**ADDENDUM NO. 1
YOUTH BASEBALL COMPLEX RENOVATION - FIELDS 11 & 12
MANDAN PARK DISTRICT
MANDAN, NORTH DAKOTA**

BID DATE: February 11, 2026

YOUTH BASEBALL COMPLEX RENOVATION FIELDS 11 AND 12 MANDAN PARK DISTRICT MANDAN, NORTH DAKOTA

YOUTH BASEBALL FIELDS 11 & 12
 MANDAN PARK DISTRICT
 MANDAN, NORTH DAKOTA
 SITE LAYOUT PLAN - FIELD 11

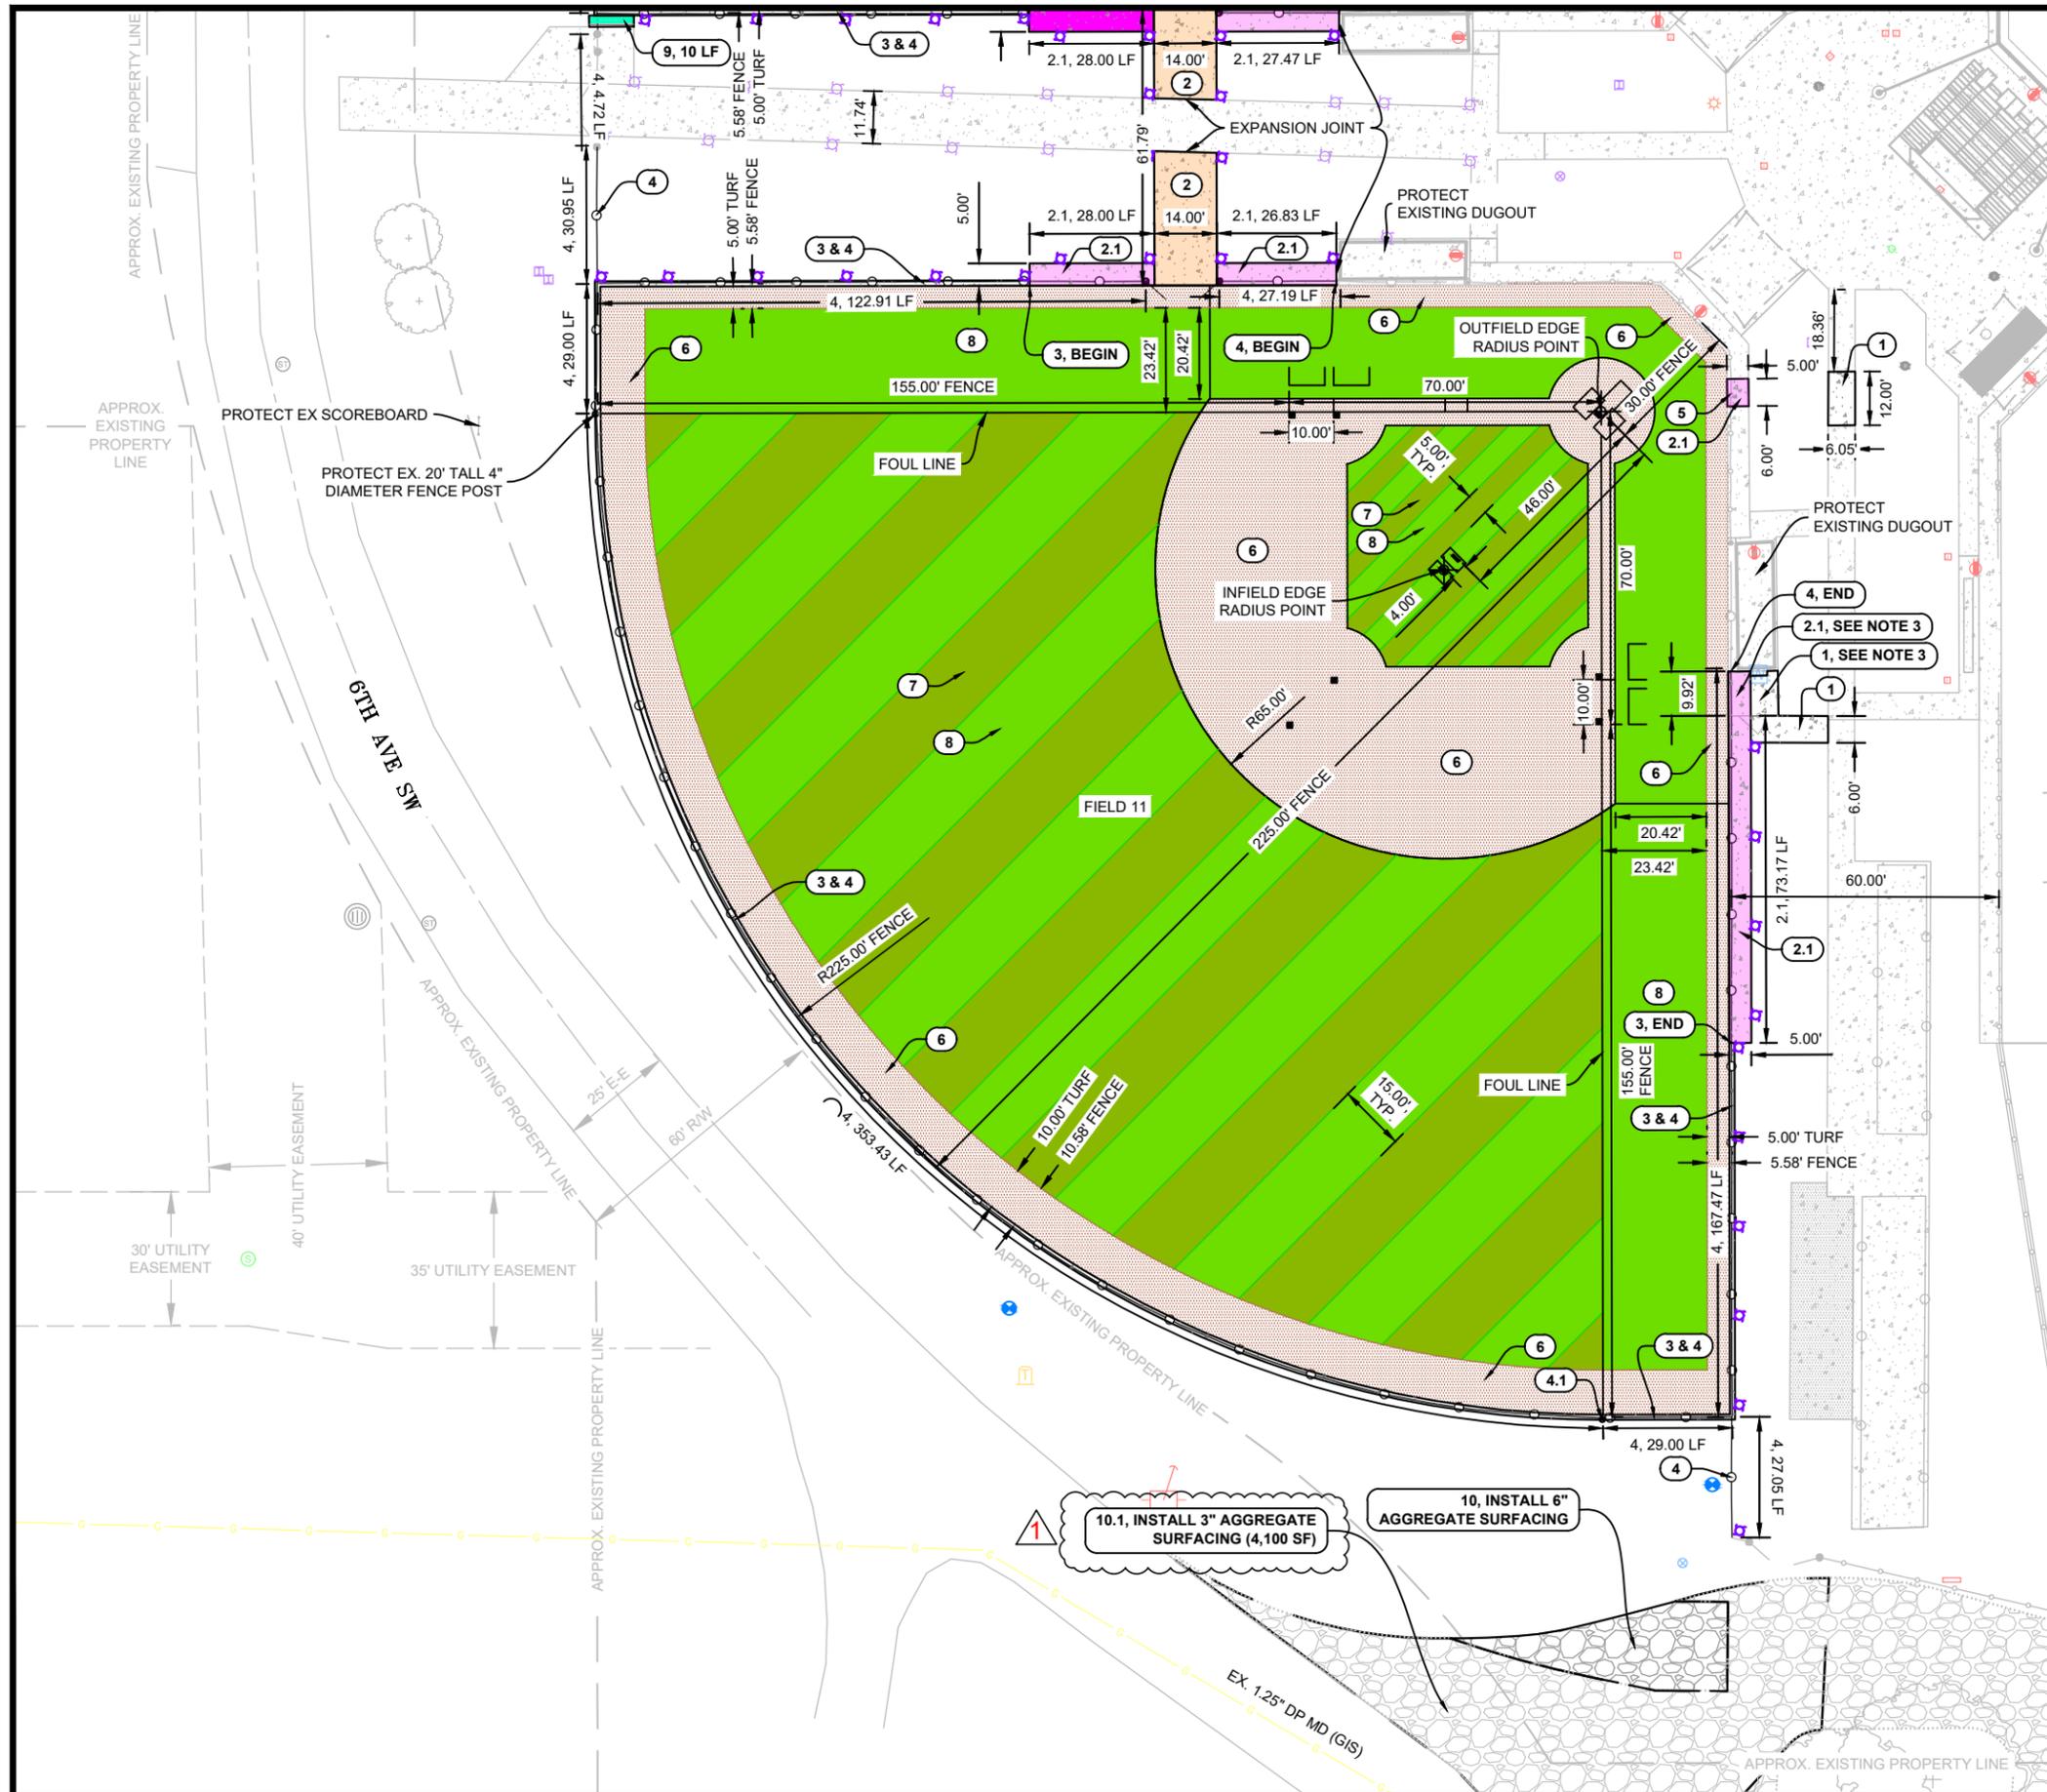
b. C4.1 - Site Layout Plan - Field 11

- i. Added square footage to 3" aggregate surfacing.

SPOT ELEVATION PLAN - OVERVIEW

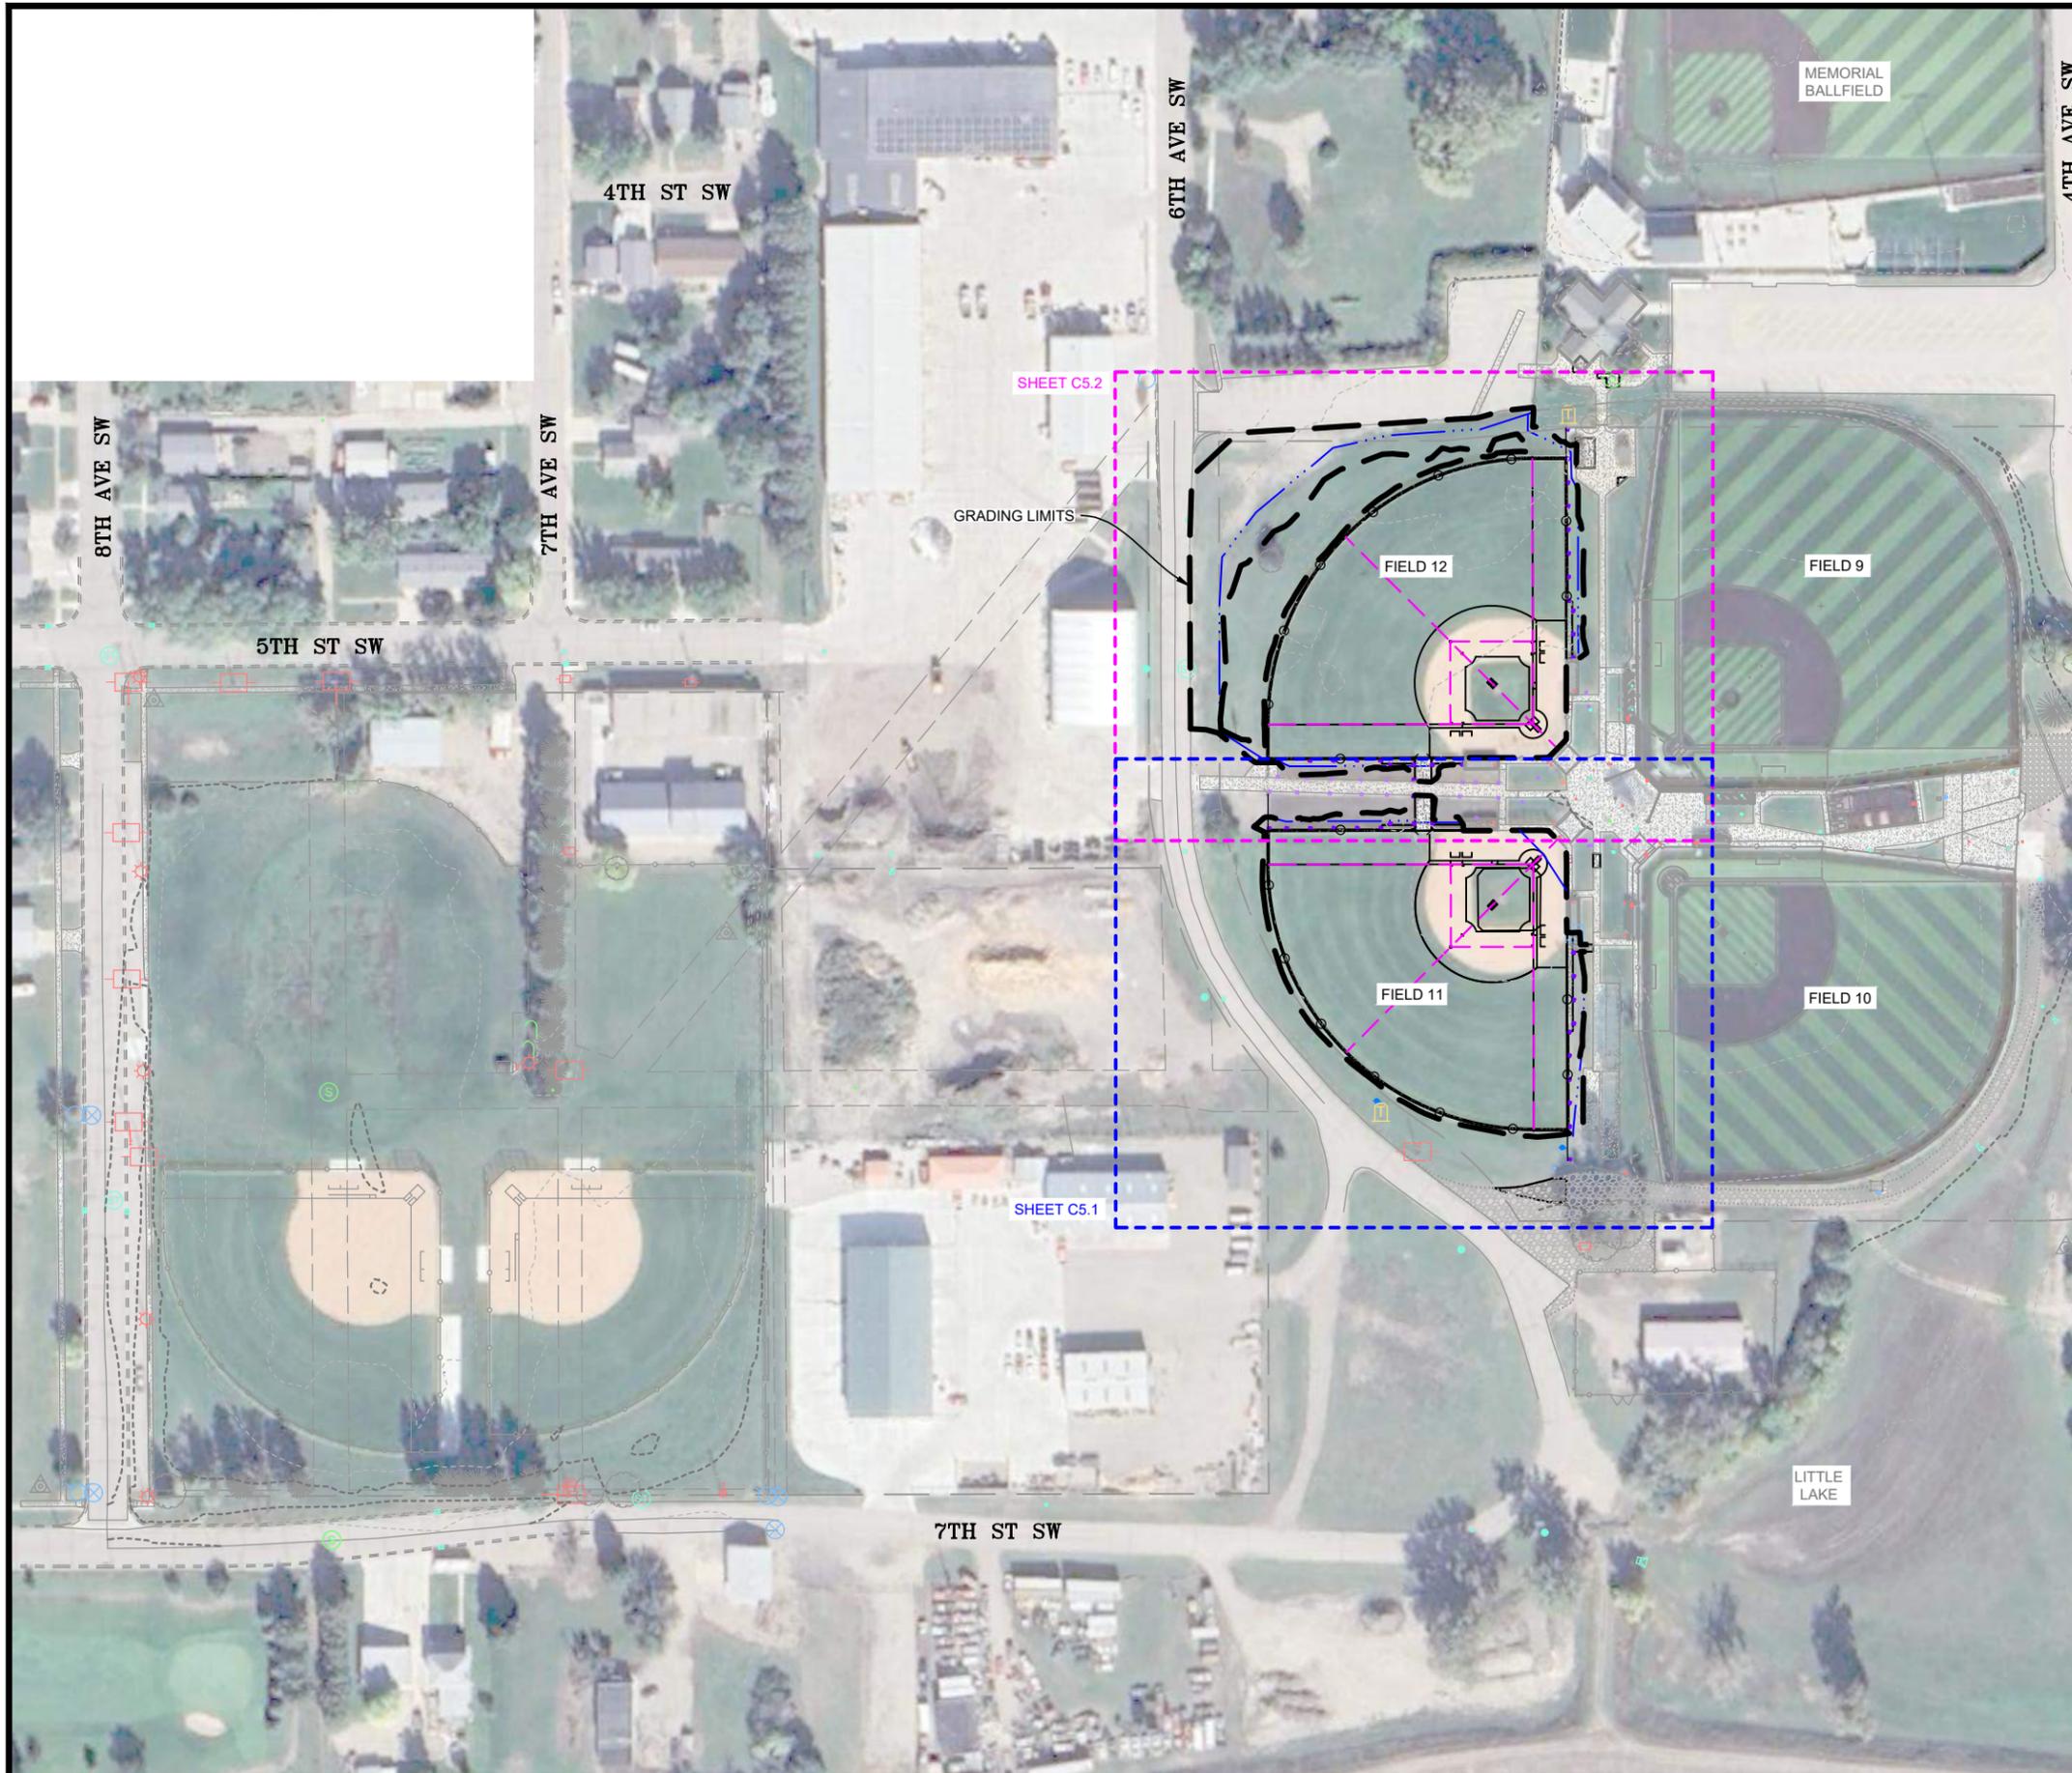
c. C5.0 - Spot Elevation Plan - Overview

- i. Added earthwork calculations.

SHRINKAGE FACTOR
 20.0% WAS ASSUMED IN CALCULATIONS FOR SHRINKAGE FOR EMBANKMENT

TOPSOIL
 TOPSOIL REMOVAL AREA = 2.74 ACRES
 ASSUMED EXISTING TOPSOIL DEPTH = 4"
 TOPSOIL REMOVED = 1,476 CY

TOPSOIL REPLACEMENT AREA = 1.00 ACRES
 TOPSOIL REPLACEMENT DEPTH = 6"
 TOPSOIL REPLACED = 805 CY

TOPSOIL BALANCE: 1,476 CY - 805 CY = 671 CY*

COMMON EXCAVATION
 EXCAVATION TO SUBGRADE = 1,162 CY (EV)
 EXCAVATION OF AGRI-LIME = 242 CY (EV) (BY OWNER)

EMBANKMENT TO SUBGRADE = 1,079 CY (CV)

TOTAL MATERIAL REQUIRED
 1,079 CY * (1+0.20) = 1,295 CY (EV)

MATERIAL BALANCE
 1,295 CY (EV) - 1,162 CY (EV) = 133 CY (EV)**

YOUTH BASEBALL FIELDS 11 & 12
 MANDAN PARK DISTRICT
 MANDAN, NORTH DAKOTA
SPOT ELEVATION PLAN - FIELD 11

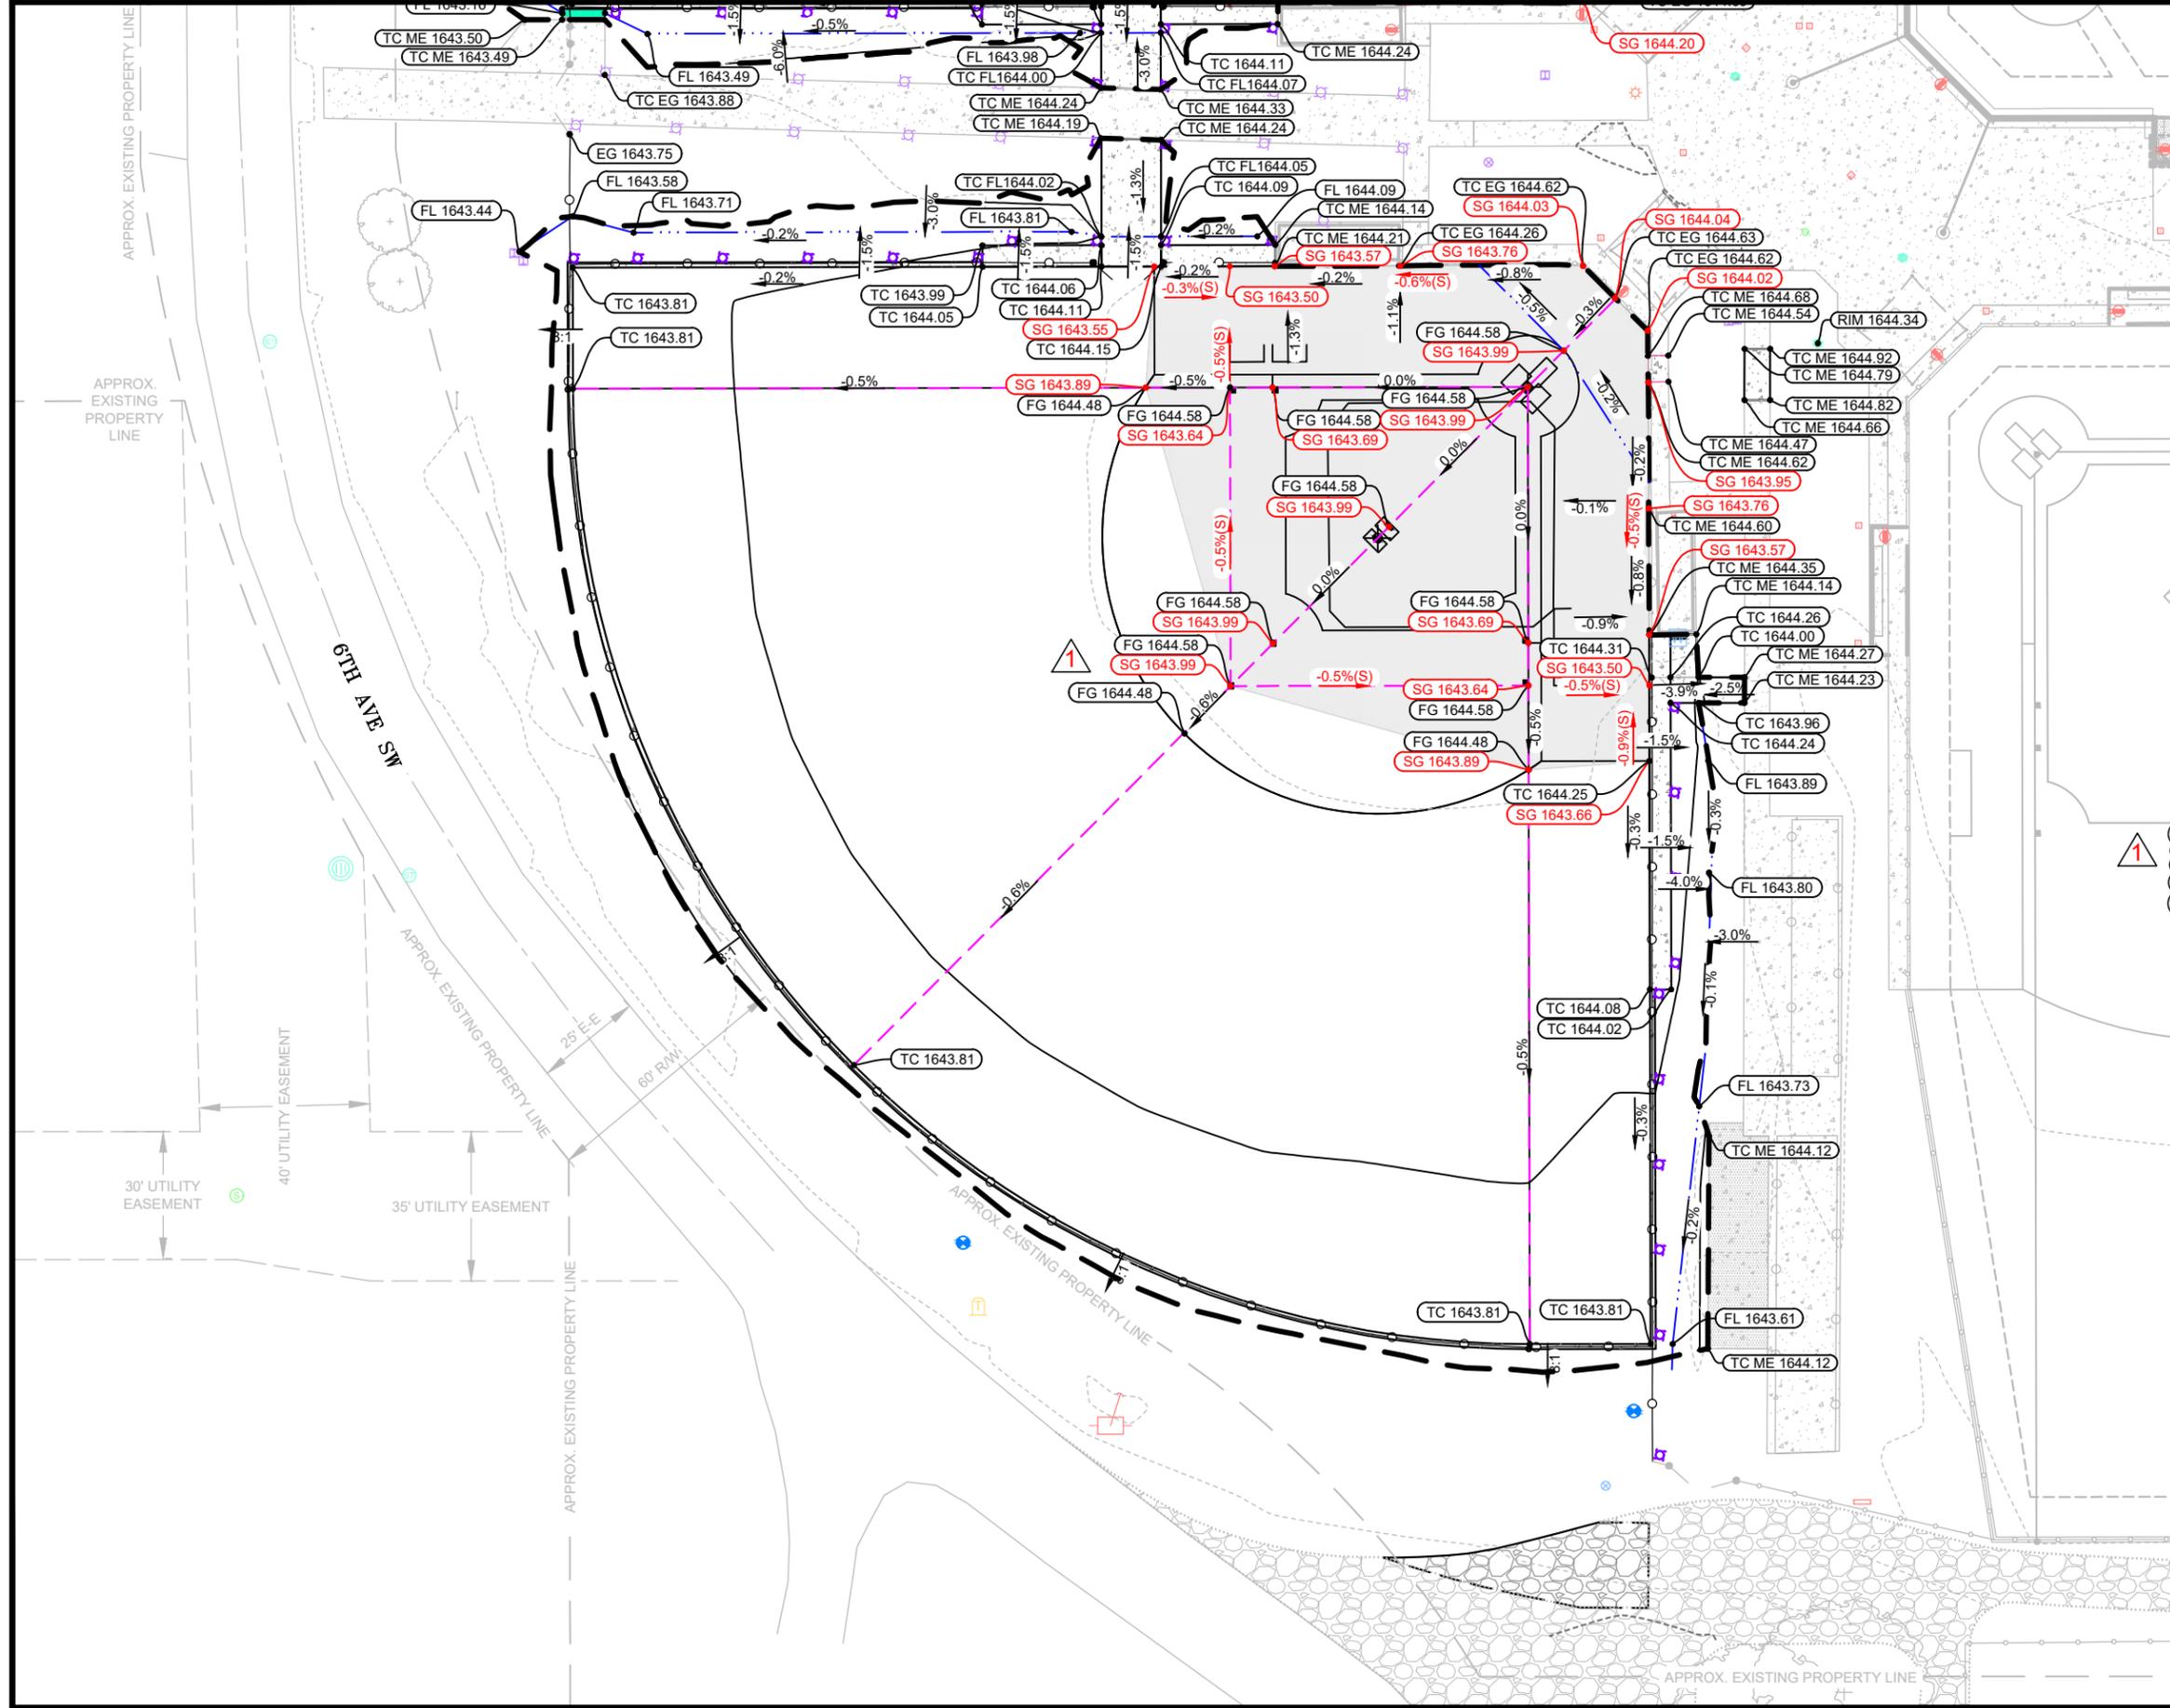
d. C5.1 - Spot Elevation Plan - Field 11

- i. Provided top of subgrade (bottom of base stone) elevations for infield.
